448-456 REERING AVENUE

CITY OF PORTLAND, MAINE

Proposed Alterations To
Residence of Mrs. Mabel G. Kennedy
452 Deering Ave., Portland, Me.
Drawn by, Robert G. Hasden

AP 452 Deering Avenue-I

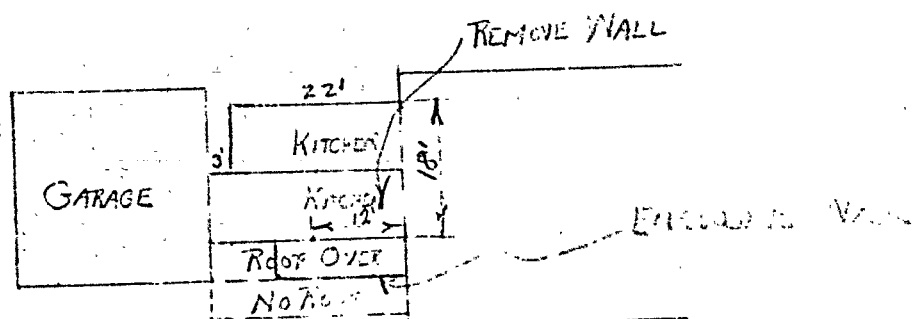
1. Mr. Arnold in answer to our letter of November 9th has said that he will provide a 4x8 header on a 12' span over the opening to be made in the existing wall of the building. If the opening is to be that wide, the 4x8 header is not adequate to take care of the loads involved. No less than a 4x12 dressed Douglas Fir or Long Leaf Yellow Pine timber is required on this span to do the job. We understood from your description of your plans that the width of the opening is to be only about 9', but even on this span the 4x8 indicated will not figure out. On the basis of a 7-foot span no less than a 4x10 dressed Douglas Fir timber is required over the opening. Therefore this permit is issued on the basis that a 4x10 dressed Douglas Fir header will be used if the opening is to be not over 9' wide or a 4x12 dressed Douglas Fir will be used if the span is to be as much as 12' wide. If you wish to use some other size timber than those indicated, approval of the size to be used is to be secured from this department before the work is started.

2. Notification is to be given this department for an inspection before the header or any of the enclosing walls are covered from view.
